ALERT SERVICE BULLETIN

NO. 427-09-28

SUBJECT: HYDRAULIC SERVOACTUATOR P/N 206-076-062-111, INSPECTION OF

FLIGHT CONTROLS – HYDRAULIC SERVOACTUATOR, PART NUMBER
41011300-103-101

Hydraulic Servo Actuator P/N 41011300
Figure 1

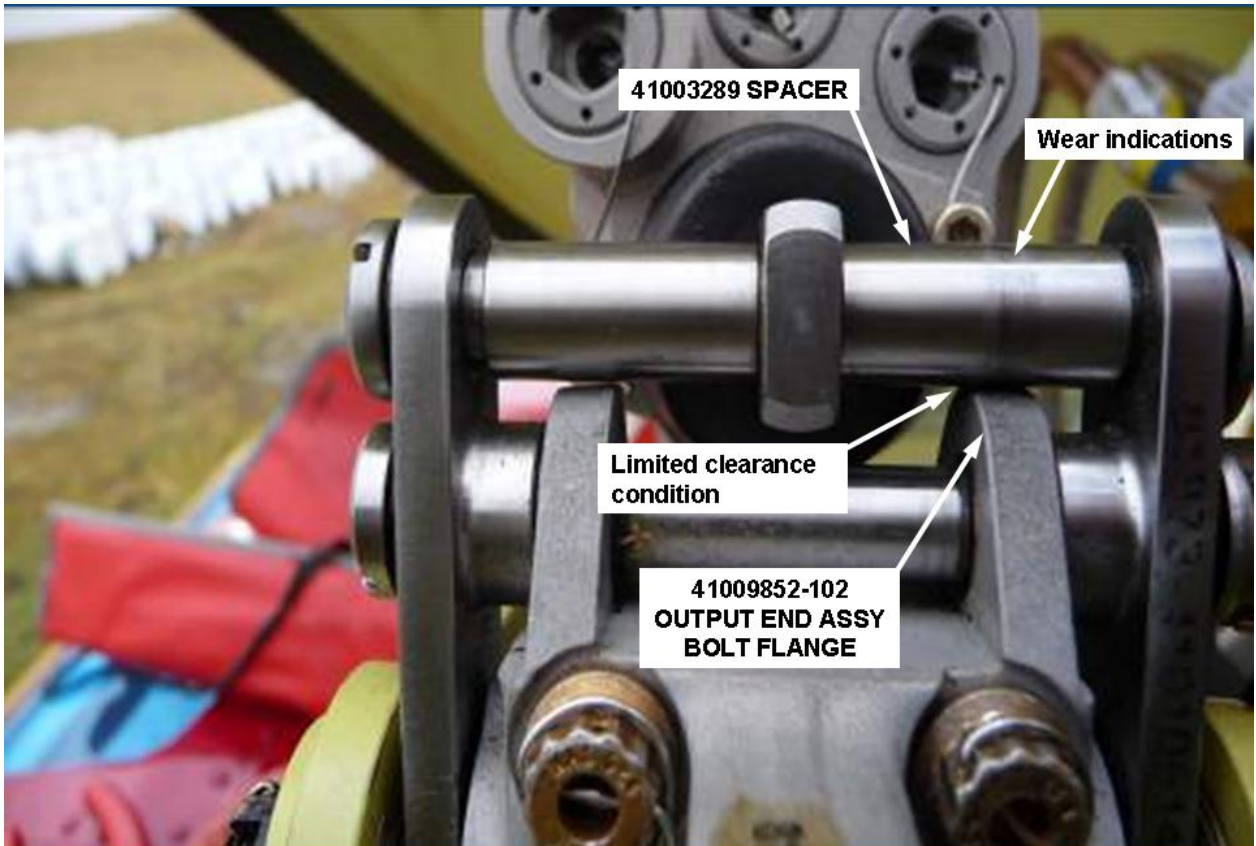
A small number of hydraulic servoactuators 41011300-103 have been discovered with limited clearance between two bolt flanges on output end assembly 41009852-101 or -102 and spacer 41003289. This limited clearance has the potential to create increased pilot input force (see Figures 1 and 2).

Clearance Data
 Figure 3

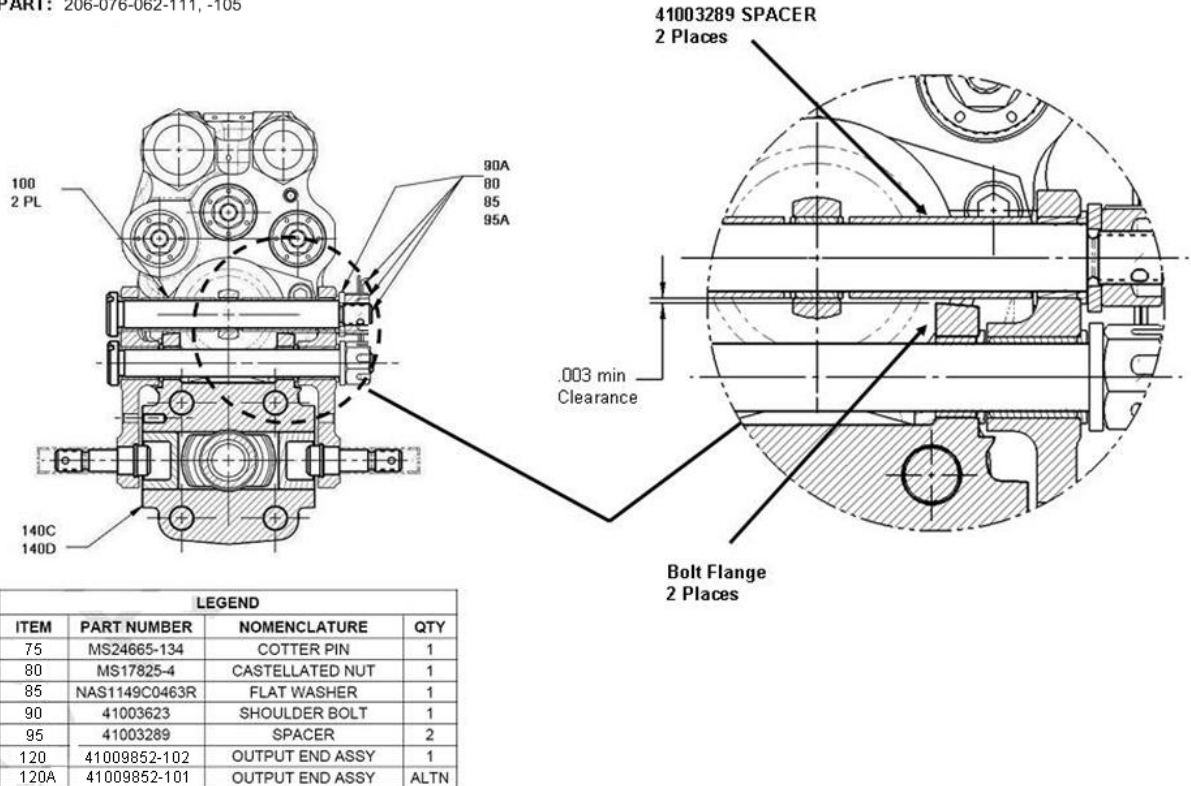
8. If the spacer does not show evidence of contact, use a feeler gauge and verify the clearance between the output end assembly bolt flange and the upper bolt spacer 41003289 as shown on Figure 3.

9. If the clearance is less than 0.003 inch, send the servo actuator to a HRT-approved service facility within the next 1200 flight hours or 12 months whichever comes first for accomplishment of Part II of this bulletin. Make appropriate entry in the helicopter and component records to show accomplishment of this bulletin and indicate findings.

Rework Instructions
 Figure 4

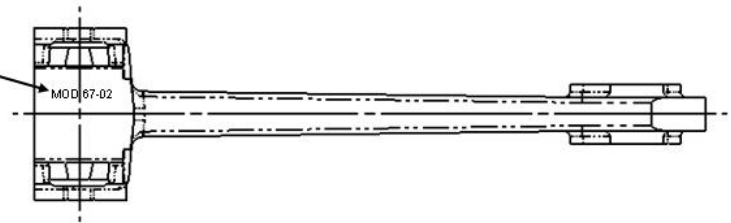
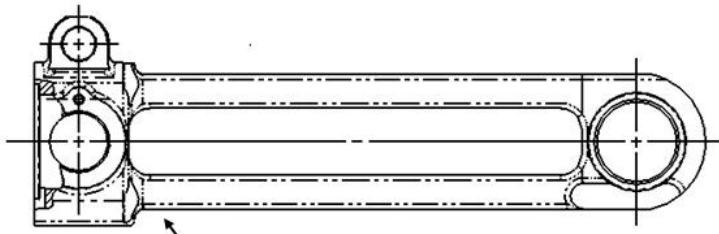
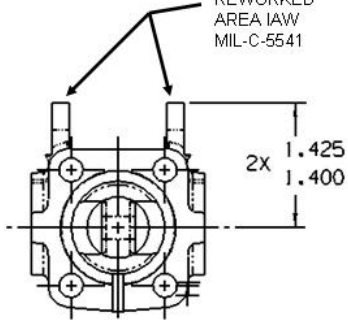
Output end assembly 41009852-101 and -102 are built using Output End 41009851-001 or -002, which are made from an aluminum forging 41009471-001 or 41009471. The ensuing investigation found flange height had not been controlled adequately on component drawings, in particular improper control of the forging draft angle.

This issue has been remedied for all new production actuators 41011300-103 Serial numbers HR1117 and later by establishing a “straight cut” with Output End 41009851-001 or -002 “Rev B” that provides adequate clearance. Fielded units and spares will be addressed by the actions of this bulletin.

2. Rework bolt flange height (2 places) to 1.400-1.425 dimension shown on Figure 4. Rework form may be a straight cut or a blended radius.
 3. Identify with identification "MOD 67-02" located on the underside of the 41009852-102 or -101 Output End as shown on Figure 4.

4. Chem-film reworked and identification area in accordance with MIL-C-5541 Class 1A.

IDENT WITH "MOD 67-02"
 .09 MIN HIGH CHARACTERS
 APPROX WHERE SHOWN.
 CHEM ETCH OR LASER ENGRAVE
 CHEM FILM REWORKED
 AREA IAW MIL-C-5541

CHEM FILM
 REWORKED
 AREA IAW
 MIL-C-5541
